SUBJECT: MILLSTONE POWER STATION, UNITS 2 AND 3 – SUPPLEMENT TO STAFF
ASSESSMENT OF RESPONSE TO 10 CFR 50.54(f) INFORMATION
REQUEST — FLOOD-CAUSING MECHANISM REEVALUATION (EPID NOS.
000495\05000336\L-2015-JLD-0011 AND 000495\05000423\L-2015-JLD-0012)

SUPPLEMENT TO
STAFF ASSESSMENT BY THE OFFICE OF NUCLEAR REACTOR REGULATION
RELATED TO FLOODING HAZARD REEVALUATION REPORT
NEAR-TERM TASK FORCE RECOMMENDATION 2.1
MILLSTONE POWER STATION, UNITS 2 AND 3
DOCKET NOS. 50-336 AND 50-423

Figure 4.0-1. Flood Event Duration

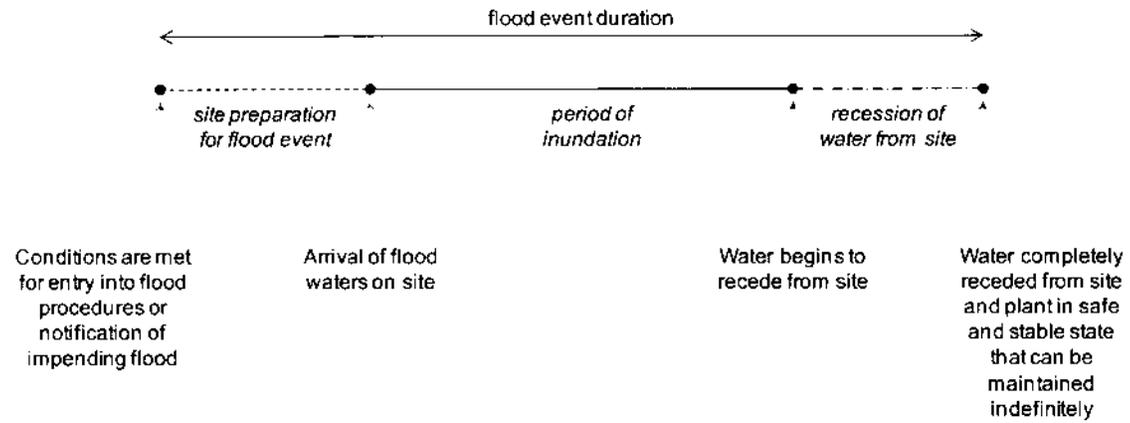
The NRC staff review concluded that the licensee's approach and methods were reasonable. Independent analyses using storm and wave simulations developed by the NRC staff confirm the duration estimates of 4 to 8 hours for the Unit 2 and Unit 3 buildings developed by the licensee provide reasonable estimates for the duration of water levels above approximately 15 ft.

Figure 4.1-1. Annotated Version of Figure 1 from FHRR Supplement (ML19011A110)

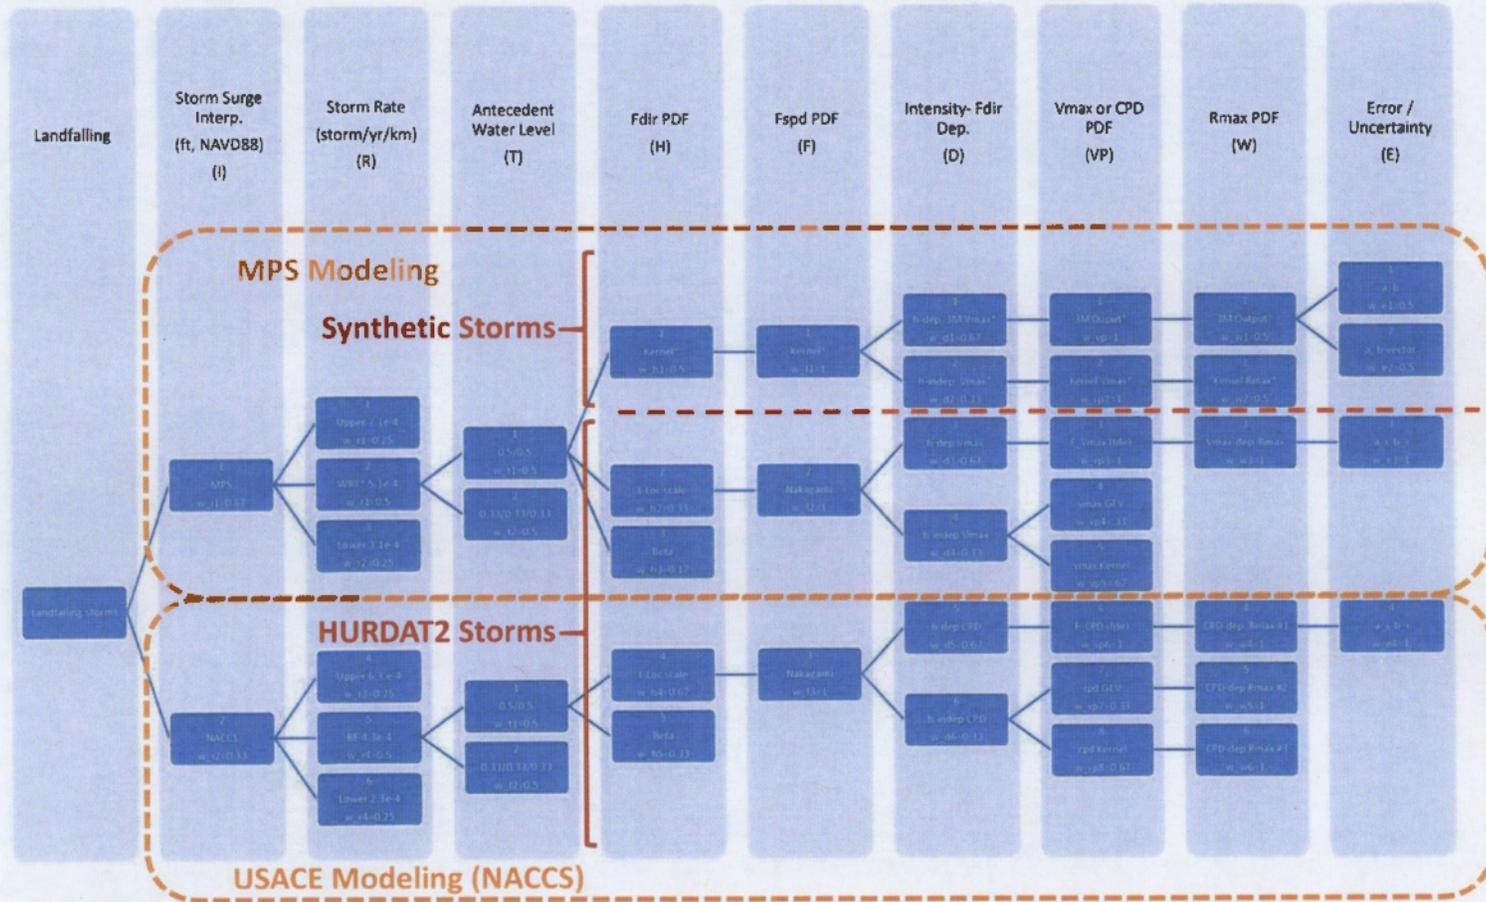
The logic tree used by the licensee is illustrated in Figure 4.1-1.

Aleatory variability of the antecedent water (Figure 4.1-1) level is shown as branches in the tree following storm recurrence rate. However, its quantification is included in the error term and as such will be discussed below in section 4.1.3.4.

A key observation by the NRC staff regarding the logic tree used by the licensee is that 75 percent of the storm surge analyses used to define the mean stillwater surge elevation with a 1E-4 AEP relied on HURDAT2 data to develop distributions describing the likelihood of observing sets of storm parameters; whereas 25 percent of the analyses were based on distributions developed using the synthetic WRT data. This was important because it demonstrated that the licensee placed significantly more confidence in the historical data for developing the likelihood of observing storm parameters for a storm track. The NRC staff performed an independent stillwater storm surge analyses using only the HURDAT2 data to evaluate the probabilities for observing a set of storm parameters.

The NRC staff found that the application of a logic tree by the licensee for the Millstone storm surge study to be acceptable. The use of logic trees to account for epistemic uncertainty is recommended in probabilistic seismic hazard studies (NRC, 2018b), and the Interagency Performance Evaluation Task Force study for New Orleans and Southeast Louisiana hurricane protection system (USACE, 2009) also incorporated epistemic uncertainty by using a logic tree. The NRC staff found weighting the two main branches equally with a weight of 0.5 to be acceptable. This weighting indicated that the licensee had equal confidence in the ADCIRC storm surge analyses specific to the Millstone site and those performed by the USACE for a nearby location. The logic tree weights resulted in 25 percent of the JPM analyses using the synthetic storm data for developing storm parameter probabilities and 75 percent used probabilities based on the HURDAT2 data. The NRC staff found the weighting of 25 percent for the WRT data and the weighting of 75 percent for the HURDAT2 data to be acceptable. The overall weighting was justified by a comparison of the licensee's mean hazard curve with the hazard curve from the NRC staff independent analyses, which produce similar results.

Figure 4.2-1. Mean Stillwater Surge Hazard Curves from Licensee and NRC Staff Evaluations.

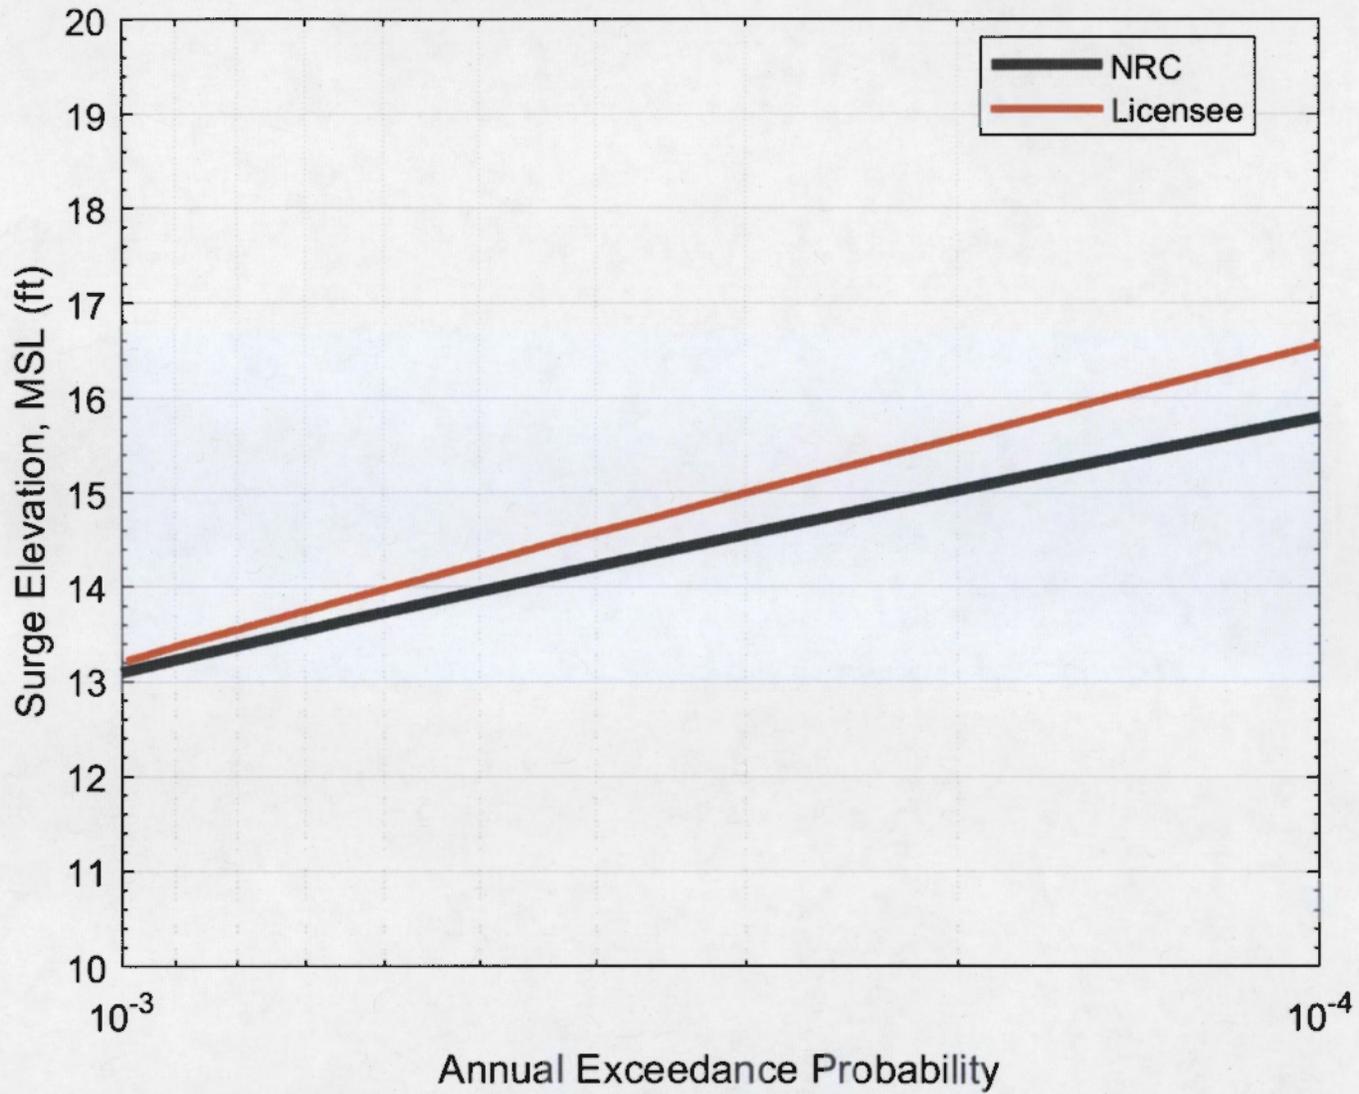
In addition to review of the components of the JPM analysis, the NRC staff compared the licensee's resulting stillwater storm surge hazard curve with results from the NRC staff's analysis. The mean surge hazard curves obtained from the licensee and the NRC staff evaluations are shown in Figure 4.2-1. These elevations included an increase in elevation due to sea level rise over the next 50 years. The licensee's stillwater surge elevation is approximately 5 percent greater than the stillwater surge elevation obtained by the NRC staff at the 1E-4 AEP. The NRC staff found this difference in results to be small for independently performed hazard studies and increases the NRC staff's confidence in the licensee's mean estimate of the stillwater storm surge hazard given the limitations in data, models, and methods available for performing this analysis.
